<b>Company</b>	Trenz Electronic GmbH
<b>PCN Number</b>	PCN-20240911
<b>Title</b>	TEI0003-03 SDRAM Change
<b>Subject</b>	BOM Change
<b>Issue Date</b>	2024-09-17

This change affects all Trenz Electronic TEI0003 Boards: TEI0003-03\*.

### 2.1 #1 Changed SDRAM (U2) from W9864G6JT-6 to W9864G6KT-6.

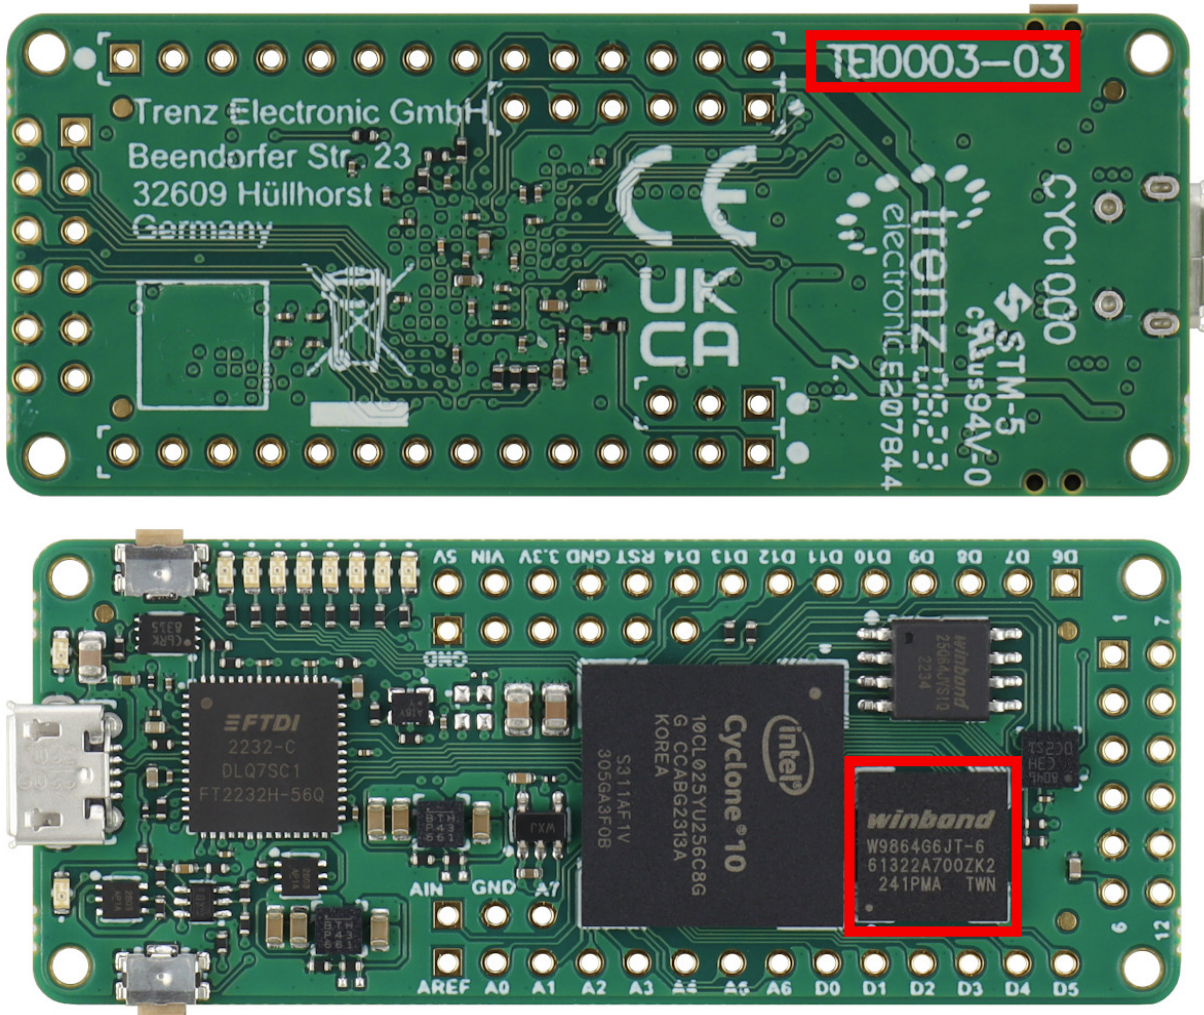
**Type:** BOM change

**Reason:** EOL of component.

**Impact:** None. New DDR timings may be considered in designs. SDRAM setup used in Trenz reference designs is known to work still.

Locate SDRAM (U2) on top side of TEI0003-03 PCB:

Old	New
W9864G6JT-6	W9864G6KT-6
